Response to Submissions Report

State Significant Development – SSD-10291

St Luke's Grammar School – Senior School Campus and Sports Centre

210 Headland Road and 800 Pittwater Road, Dee Why and 224 Headland Road, North Curl Curl

Figure 5 Stage 2 Drop-off and pick-up spaces (Varga Traffic Planning)

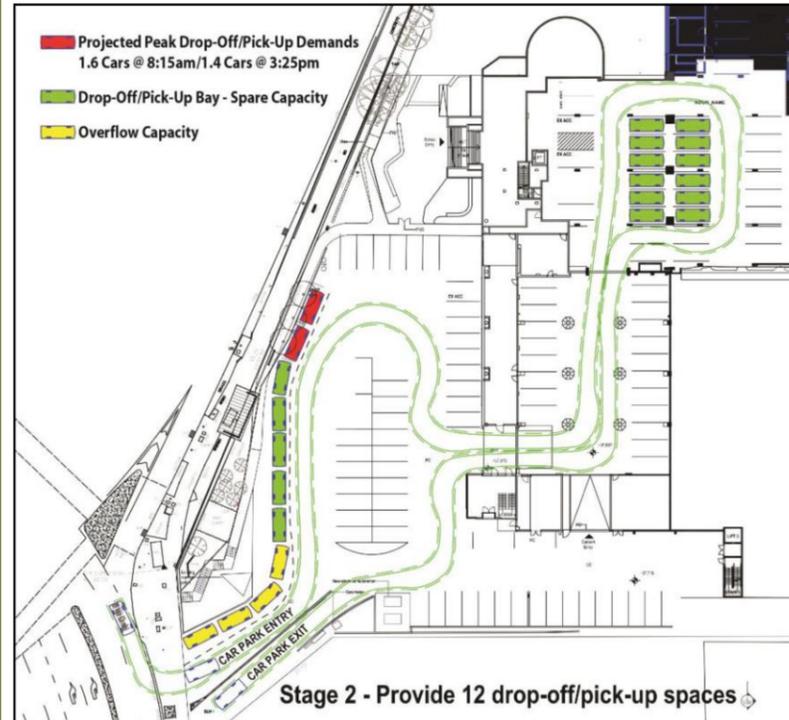
1.1.2	Provide further clarification regarding the information provided in the submitted traffic report including: <ul style="list-style-type: none"> analysis and information to address the potential impacts due to queuing of vehicles utilising the proposed pick-up and drop-off areas. 	As described above, a maximum pick-up / drop-off capacity for 23 vehicles is provided in Stage 2 of the proposed development and a maximum pick-up / drop-off capacity for 28 vehicles is provided in Stage 3 of the proposed development. This is adequate to cater for the maximum peak drop-off / pick-up demand of two (2) vehicles without impacting on traffic flows within the site or on the adjoining signalised intersection.	Attachment 12																																									
	<ul style="list-style-type: none"> further reasons and / or analysis to justify that the impacts on the local traffic network would reduce as a result of the proposed change of use to a school. 	<p>The Traffic and Parking Matters (Response to Submissions) prepared by Varga Traffic Planning provides an assessment of the impacts of the proposed development on the traffic generated by 800 Pittwater Road and the traffic generated by 210 Headland Road (the existing school campus). This assessment was based on additional traffic and parking surveys undertaken for both sites. The assessment found that there will be a substantial reduction in the traffic generated by 800 Pittwater Road from 3,224 vehicles per day to 644 vehicles per day. There will also be a reduction in traffic generated by the site during the AM and PM school peak periods.</p> <p>As discussed below, the proposed changes to the student mix at 210 Headland Road will result in a minor increase in traffic generation during the AM and PM peak school periods at the existing school campus.</p>	Attachment 7 Attachment 9 Attachment 12

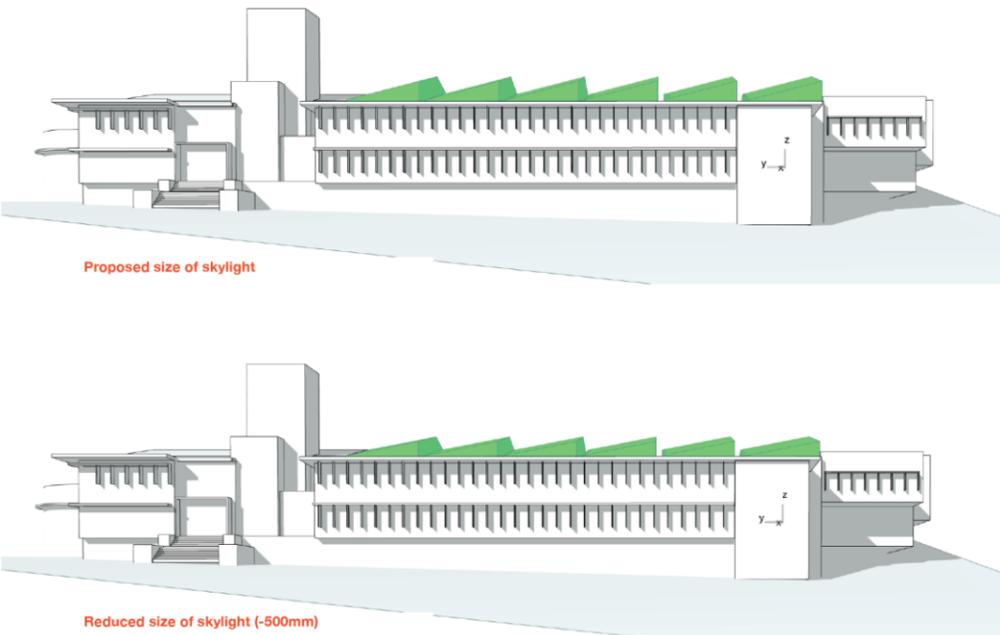
1.2.2	<p>The Department concurs with the comments from Northern Beaches Council (Council) regarding the provision of a second elevator to connect the two sites and the revision to the roofline at 800 Pittwater Road, and considers that this should be addressed in the RTS.</p>	<p>Second Lift A second lift has been provided within the vertical circulation building linking 800 Pittwater Road and 224 Headland Road (Figure 16).</p>  <p><i>Figure 16 Level 5 showing two lifts within the vertical circulation</i></p>	<p>Attachment 2 Attachment 3 Attachment 4</p>

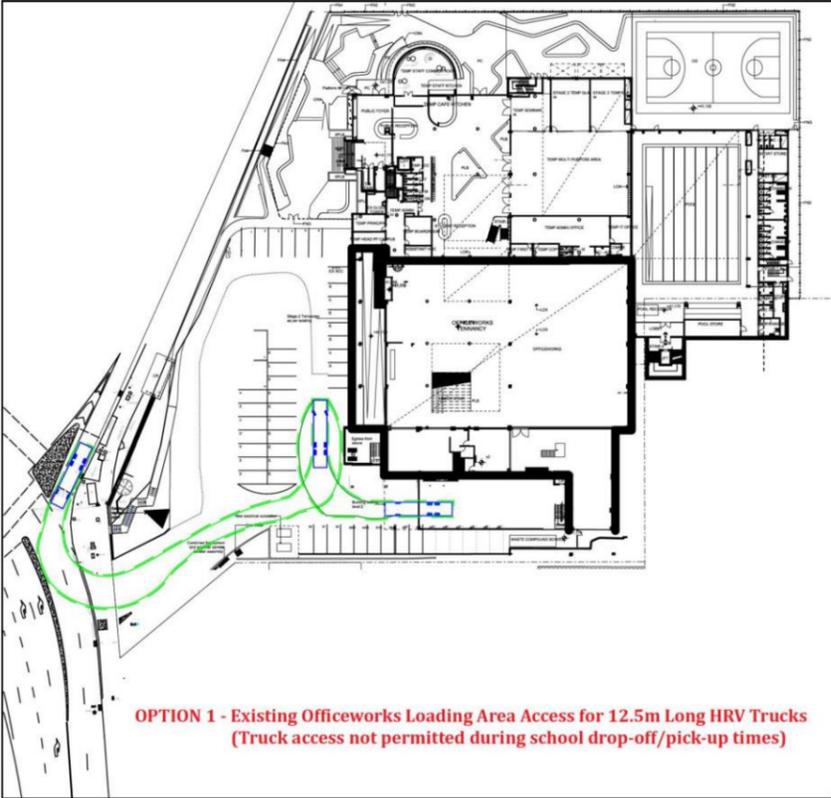
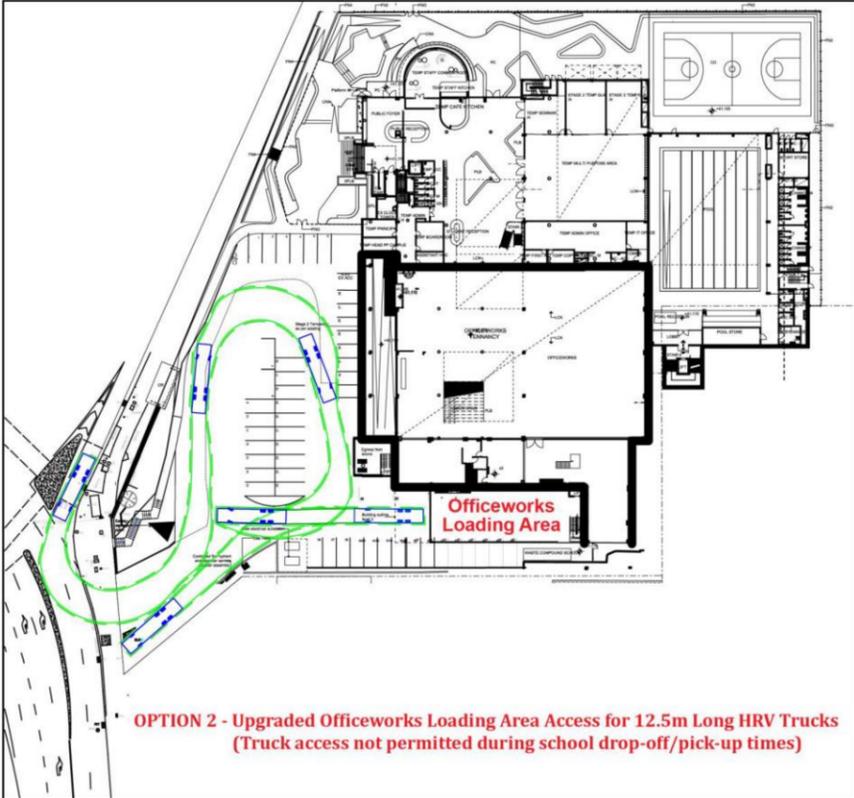
2.2 Traffic Impact			
2.2.1	<p><u>Comment</u> The traffic report did not include supporting information to demonstrate that the pickup and drop-off activities on the proposed pickup and drop-off area will not have adverse impact on the adjacent road network. TfNSW is concerned that the vehicle queuing at the proposed pickup and drop-off area will overflow to Harbord Road, which results in obstruction at the signalised intersection.</p> <p><u>Recommendation</u> The Proponent is requested to provide analysis and information to address the potential queuing issue at the proposed pickup and drop-off area.</p>	<p>Additional traffic surveys of the existing school were undertaken by Varga Traffic Planning to determine the drop-off and pick-up demand generated by the senior school students. There is a current enrolment of 303 senior school students. The analysis was undertaken at 5-minute intervals to determine the average number of cars that will be stopped to drop-off or pick-up senior school students during each 5-minute period (Figure 18).</p> <p>Figure 18 Results of drop-off and pick-up surveys senior school students (number of cars per 5 minutes).</p>	Attachment 7 Attachment 10 Attachment 12

Item #	Issue	Response	Reference
		<p>The results found that the peak-time for drop-off was 8:15am with a maximum of 10 cars undertaking drop-off during that 5-minute interval. The peak-time for pick-up was 3:25pm with a maximum of 4 cars undertaking pick-up during that 5-minute period. The survey also found that the average drop-off duration was 30 seconds per car and the average pick-up duration was 70 seconds.</p> <p>These results were extrapolated for Stage 2 when there is a maximum of 480 senior students enrolled at 800 Pittwater Road (Figure 19) and for Stage 3 when there is a maximum of 600 students enrolled at 800 Pittwater Road (Figure 20).</p>  <p><i>Figure 19 Projected future senior school drop-offs and pick-ups in Stage 2 (Number of cars per 5 minute interval)</i></p>  <p><i>Figure 20 Project future senior school drop-offs and pick-ups in Stage 2 (number of cars per 5 minute interval)</i></p> <p>The projections found that the maximum number of cars:</p> <ul style="list-style-type: none"> • Dropping off senior school students during Stage 2 was 16 cars during 5 minute interval at 8:15am; • Picking up senior school students during Stage 2 was 6 cars during the 5 minute interval at 3:25pm; • Dropping off senior school students during Stage 3 was 20 cars during the 5 minute interval at 8:15am; and • Picking up senior school students during Stage 3 was 8 cars during the 5-minute interval at 3:25pm. <p>It was therefore concluded that peak:</p> <ul style="list-style-type: none"> • Drop-off demand in Stage 2 will be 1.6 cars at 8:15am (Figure 21); • Pick-up demand in Stage 2 will be 1.4 cars at 3:25pm (Figure 21); • Drop-off demand in Stage 3 will be 2 cars at 8:15am (Figure 22); and • Pick-up demand in Stage 3 will be 1.9 cars at 3:25pm (Figure 22).

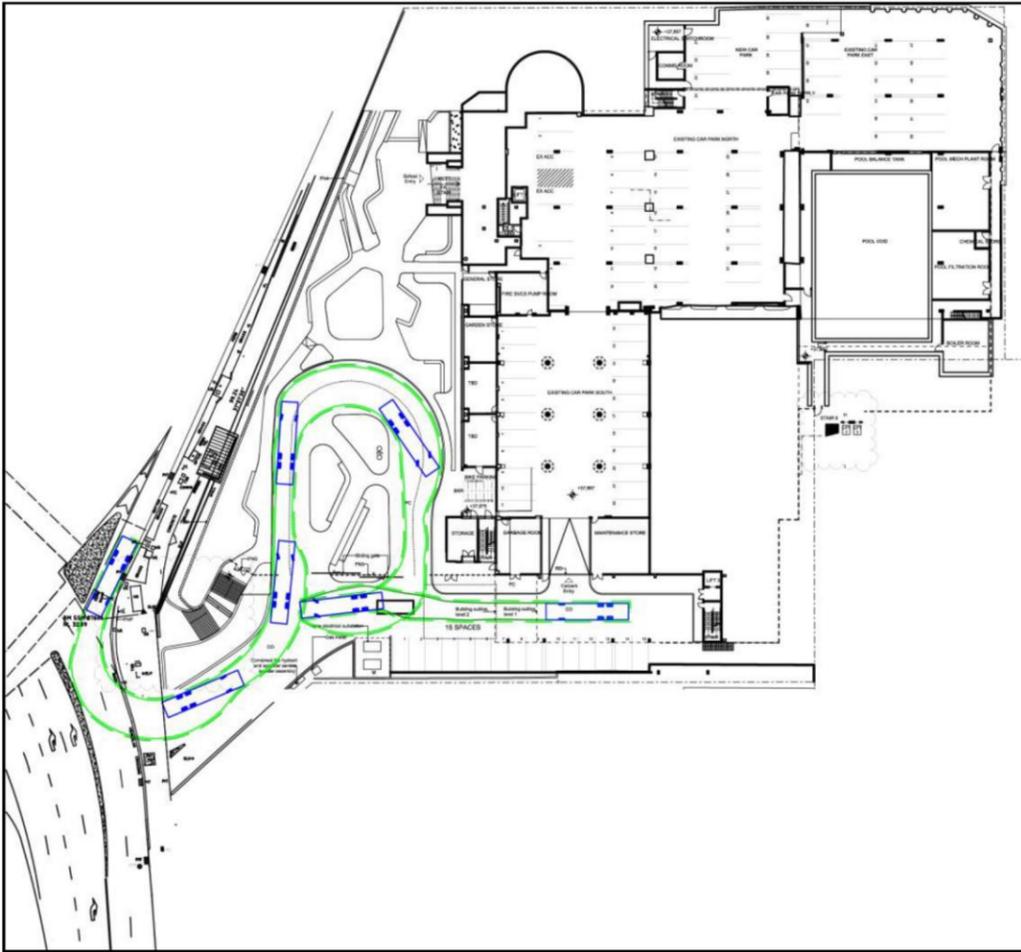
2.2.3	<p data-bbox="344 1602 744 1833">Comment The swept path diagrams in the traffic report indicate that the manoeuvre of a HRV encroaches the pickup and drop-off area. In particular during Stage 2, these pickup and drop-off spaces will be likely occupied by the vehicles associated with the Officeworks during off-peak period. This will potentially obstruct the vehicle movement on site and result in potential vehicles queuing back to Harbord Road.</p>	<p data-bbox="795 1602 2502 1694">Currently trucks servicing Officeworks use the loading dock located at the southern end of the site. These trucks currently make a three-point turn using the end of the existing car park aisle (Figure 23). It proposed that during Stage 2, Officeworks trucks will be able to drive around the carpark to avoid having to make a three-point turn (Figure 24). This will only be able to occur outside of the school's drop-off and pick-up periods. Officeworks customers will not be permitted to use the drop-off and pick-up bays, which will clearly indicated through the use of line markings and/or signposting.</p> <p data-bbox="795 1715 2516 1808">Based on traffic surveys conducted at the Officeworks loading dock over a five (5) day period (6:30am and 7:30pm), there were two (2) heavy vehicle deliveries during this period. Both of these heavy vehicle deliveries occurred between 9am and 3pm, when there will be minimal traffic activity generated by the school use. Deliveries by smaller trucks and vans also mainly occur between 9am and 3pm. It is proposed to prepare a site-specific Plan of Management with Officeworks for Stage 2 that will stipulate that no heavy vehicle deliveries are to occur during the peak AM and PM periods (7am – 8:30am and 3pm – 4:30pm).</p>	Attachment 7

Item #	Issue	Response	Reference																																																									
	<p><u>Recommendation</u> The Proponent is requested to revise the design of the car parking area allowing manoeuvre of a HRV without any encroachment.</p>	 <p>OPTION 1 - Existing Officeworks Loading Area Access for 12.5m Long HRV Trucks (Truck access not permitted during school drop-off/pick-up times)</p> <p>Figure 23 Existing Officeworks truck access arrangements.</p>  <p>OPTION 2 - Upgraded Officeworks Loading Area Access for 12.5m Long HRV Trucks (Truck access not permitted during school drop-off/pick-up times)</p> <p>Figure 24 Access for Officeworks trucks during Stage 2</p>

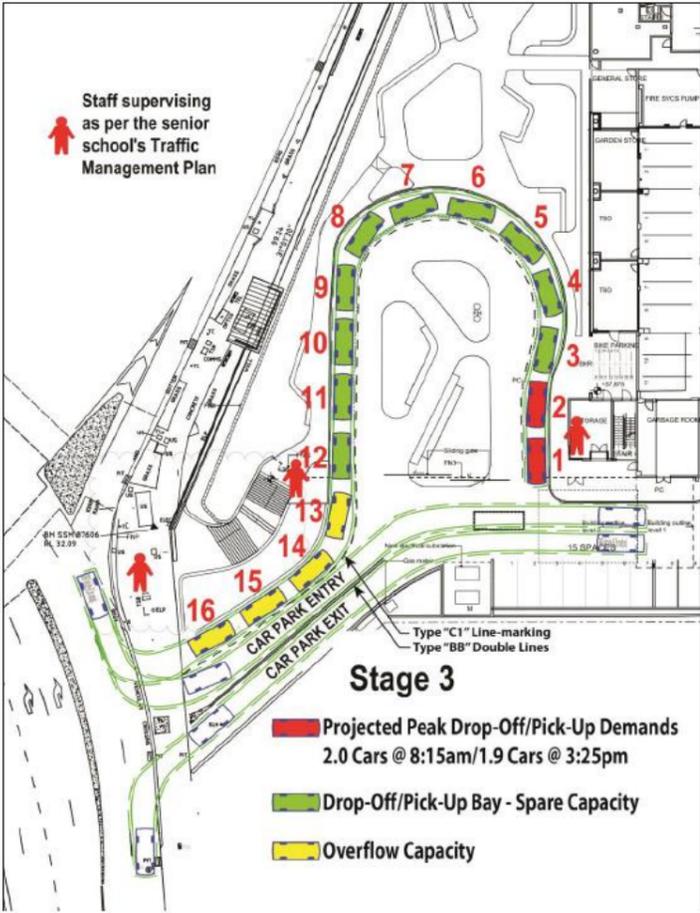
2.9 School Operational Management Plan			
2.9.1	<p><u>Comment</u> It is noted that pedestrian access on the south-west corner of the site at 800 Pittwater Road would lead to high number of students and parents waiting at the corner of a busy intersection with limited waiting area. This would have the potential for pedestrians to use travel lanes for waiting area and cause pedestrian related incidents.</p> <p>It is advised that any direct pedestrian access onto multi-lane road should be avoided where possible. The existing north-west pedestrian access can still provide direct connection to the school entry from the protected pathway to Pittwater Road."</p> <p><u>Recommendation</u> It is requested that the applicant be conditioned to prepare a School Operational Management Plan, in consultation with TfNSW, to manage student movements safely within and in the vicinity of the site and other transport related issues, prior to the issue of the occupation certificate.</p>	<p>The proponent has no objections to the inclusion of a condition of consent prior to the issuing of an Occupation Certificate, that requires a new School Operational Management Plan to assist in managing student movements safely within and in the vicinity of the site (including other transport related issues).</p> <p>To address safety concerns for students and parents waiting outside the school site, a new pedestrian fence is proposed along the kerb line where the existing pedestrian fence terminates, through to the existing driveway in Harbord Road. Furthermore, pedestrian safety and flow will be managed through staff supervision at any pick-up and drop-off points, as well as near the site access driveway and the signalised pedestrian crossing</p>	Attachment 7

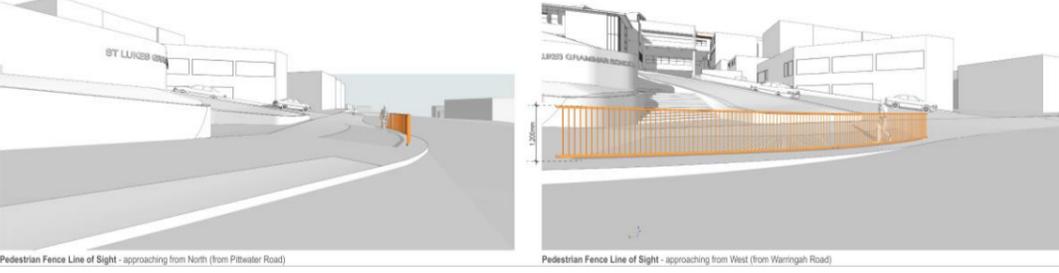
Item #	Issue	Response	Reference
	<p>other vehicles to enter the site. This would cause queuing on to public roads; and</p> <ul style="list-style-type: none"> Parents would arrive to the site and queue at the school gate well before the school opens. This would also cause queuing on to public roads. <p>Based on the above, the proposed activities associated with the development would likely cause queuing on public roads and increase pedestrian / vehicle conflicts and cause pedestrian related incidents at the entrance to the school with the increase in pedestrian movements. Vehicle movements need to be either restricted or reduced from this driveway to provide a safer environment for pedestrians as well as vehicles at this location.</p>	<p>during the Junior School pick-up from Tango Avenue. A similar strategy can be adopted for the senior school campus at 800 Pittwater Road. The strategy would include:</p> <ul style="list-style-type: none"> Parent's displaying surname of student on passenger side sun visor; Drivers to always remain with their vehicle; Students to enter the car from the passenger side and keep bags with them; and Staff supervision at key vantage points (Figure 28). <p>The pick-up and drop-off arrangements during Stages 2 and 3 have been designed to ensure that these spaces do not impede traffic flow or access to the forecourt parking or basement carpark.</p> <p>No gates are proposed to be provided to the driveway. Roller shutters will restrict access to the basement carpark outside of operational hours.</p>  <p>Figure 28 Proposed Stage 3 Senior School Drop-Off/Pick-Up Bays and carpark access (Varga Traffic Planning)</p>

3.1.2	<p>To reduce the potential queuing concerns raised above TfNSW requests that the submitted plans and documentation are amended so that the Harbord Road vehicular access can only be used by school staff. Student pick up and drop off and student parking facilities are not to be provided on the Senior Campus.</p> <p>This is due to the driveway location immediately next the Pittwater Road and Warringah Road signalised intersection. Any overflowing vehicle to Harbord Road will immediately result in significant traffic congestion not only at the signalised intersection but also to the broad road network.</p>	<p>As outlined in this RTS report, it is appropriate to provide student pick-up, drop-off and parking facilities at 800 Pittwater Road. Subject to the management measures outlined in the RTS report, the proposed development will not have an impact on the operation of the Pittwater Road / Warringah Road / Harbord Road intersection.</p>	Attachment 10
